12. **Project# 1007802**
09DRB-70180 SKETCH PLAT REVIEW
AND COMMENT

DRB Comments

RE: Lot 20, Block 30, Ridgecrest Addition

DESCRIPTION OF REQUEST: sketch plat review for excess right-of-way purchase.

1800 Ross Pl SE - Site Plan

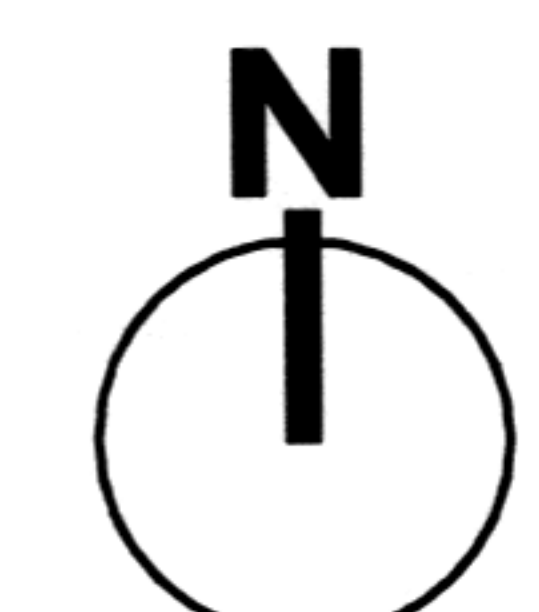
Refer to comments from Transportation Development regarding proposed vacation; generally, the City must have 9 feet of right-of-way behind the curb of a local street, with a 4 foot sidewalk. A wall or fence cannot exceed 3 feet in height within the required front yard (Ross Place), with some exceptions possible through a Conditional Use Permit; contact Zoning Enforcement, the division that will be reviewing and approving any wall or fence permit.
